STAFF REPORT: 2/8/2023 REGULAR MEETING

APPLICATION NUMBER: #23-8209

ADDRESS: 8469 E. JEFFERSON (BOOK MANSION)

SCOPE: INSTALL FENCE, INSTALL FRENCH DOORS AND WINDOWS

West elevation door infill removed in 2012

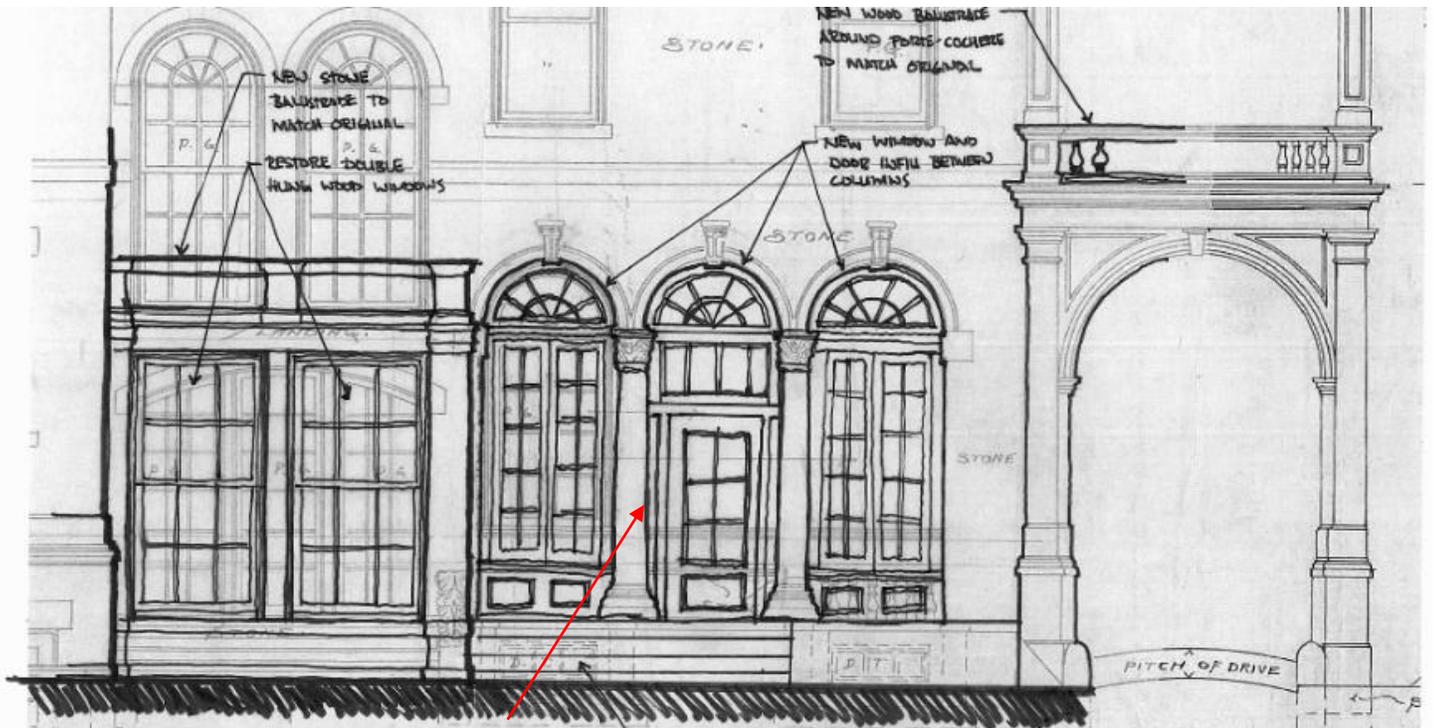
- A previous owner removed the doorway infill from the loggia's west elevation and demolished the non-original breezeway per the 2012 Commission approval, but never did follow through with their plan to install windows and doors within the now exposed/exterior fenestration openings at the loggia's north and west elevations and the solarium's west elevation. Currently these openings are covered with plywood, the current application proposes new doors/windows to be installed in these locations.

- The current application is proposing to install new wood windows and doors within the west and north elevation of the loggia and new doors at the west elevation of the solarium. However, the applicant is seeking to revise the design of the fenestration that was approved in 2012. See the above graphics which depict the design of the fenestration that was approved in 2012, which includes multiple-lite French doors with wood panel bases. The design of the new fenestration proposed in the current application appears to replicate the existing French windows/doors at the building's side and front elevations, first story. Specifically, the new fenestration calls for a set of paired, full-height, multiple-lite wood French doors which is topped with a fixed, arched multiple-lite transom in each opening.

- The new windows/doors proposed for the loggia's north and west elevations and the doors proposed for installation at the solarium's west elevation are compatible with the building's historic appearance and do meet the Secretary of the Interior's (SOI) Standards in staff's opinion.
